ENTERGY NUCLEAR VERMONT YANKEE, LLC and
ENTERGY NUCLEAR OPERATIONS, INC.Docket No. 50-271-LR
ASLB No. 06-849-03-LR

Vermont Yankee Nuclear Power Station

NEW ENGLAND COALITION, INC.'S MOTION FOR LEAVE TO FILE
A TIMELY NEW CONTENTION AND MOTION TO HOLD IN ABEYANCE
ACTION ON THIS PROPOSED CONTENTION UNTIL
ISSUANCE OF NRC STAFF SUPPLEMENTAL SAFETY EVALUATION REPORT**I. INTRODUCTION AND MOTIONS**

**DECLARATION OF DR. JORAM HOPENFELD
IN SUPPORT OF NEW ENGLAND COALITION'S MOTION
TO FILE A TIMELY NEW OR AMENDED CONTENTION
ON ENTERGY'S FATIGUE REANALYSIS**

FIG. 8-9. Local Nusselt numbers for flow through a tube near the entrance with simultaneous development of the flow and temperature field. [From W. Linke and H. Kunze, *Allgem. Wärmetechn.*, 4:73-79 (1953).]

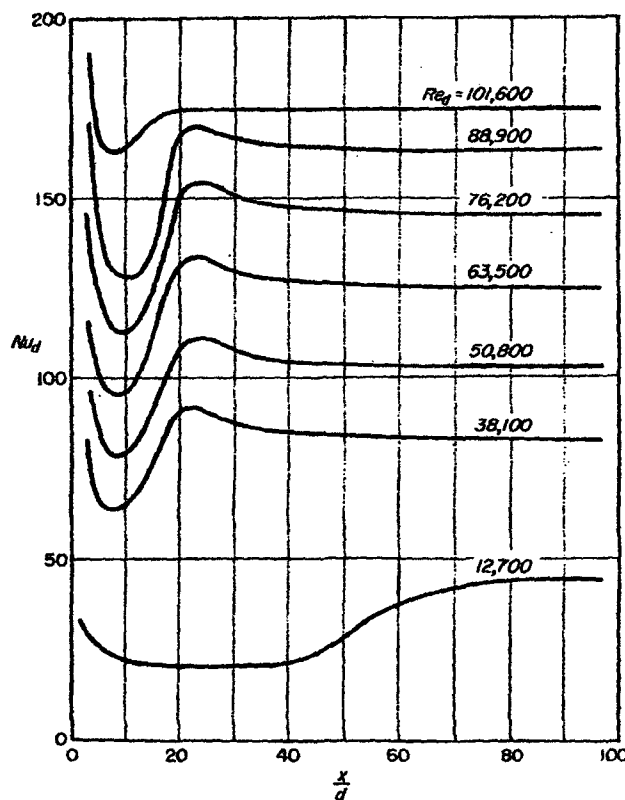
A11. Entergy stated that the flow through the FW nozzle was fully developed because they claimed that for that specific geometry of the FW nozzle, five diameters is sufficient for the flow to become fully developed. Entergy's statement clearly differs from all textbooks on thermal hydraulics clearly showing that 25- 40 diameters are required for the flow to become fully developed.

Further, Entergy does not provide any data to support the proposition that 5 diameters is sufficient length for full flow to develop. Even in the unlikely event that such data exist, and even if one were to accept Entergy’s contention that there is no difference between flow in a straight pipe and the flow in a convergent nozzle, the flow in the RO nozzle will not be fully developed because the RO nozzle diameter varies between 26 and 36 inches. Since the RO nozzle length is less than 150 inches (30x5), the flow in the RO nozzle can not be fully developed. The large axial and circumferential variation in the heat transfer will affect the maximum stress distribution during transients, leading to a different CUFen than was calculated by Entergy.

Fig. 5.15. Velocity distribution in a convergent and a divergent channel after G. Hamel [10] and K. Millsaps and K. Pohlhausen [21]

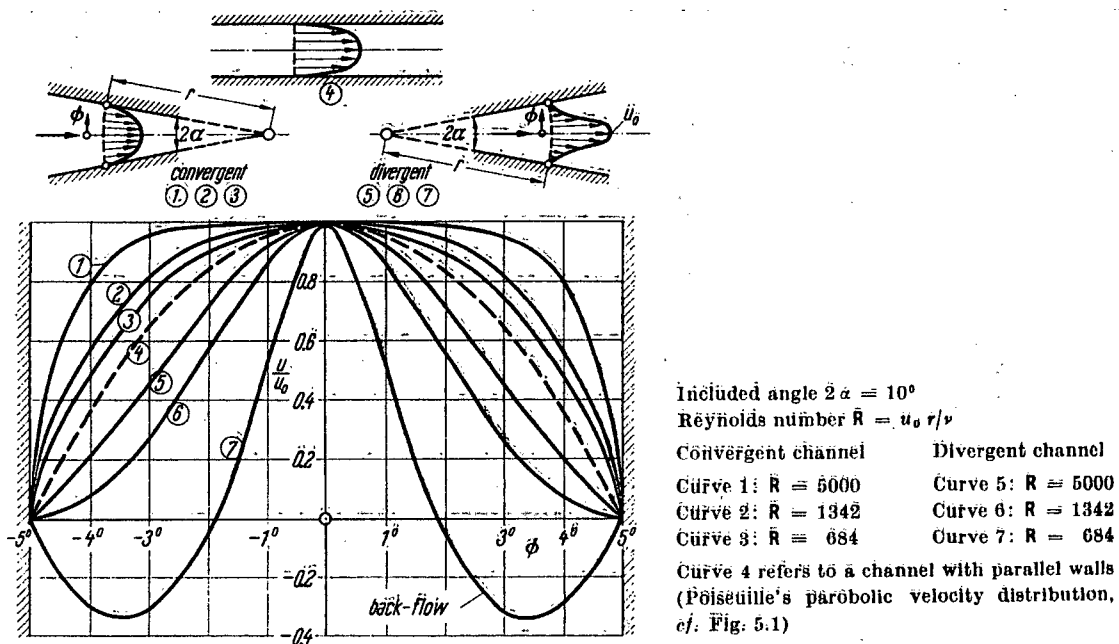
Velocity Distribution in a Convergent Channel (RO Nozzle) In Comparison to a Flow in a Straight Pipe. H. Schlichting, Boundary Layer Theory, 4th Ed. 1960. P 90

(See, Entergy Reanalysis Calculation Package 0801038.304R, Assumption 4 under 3.1)
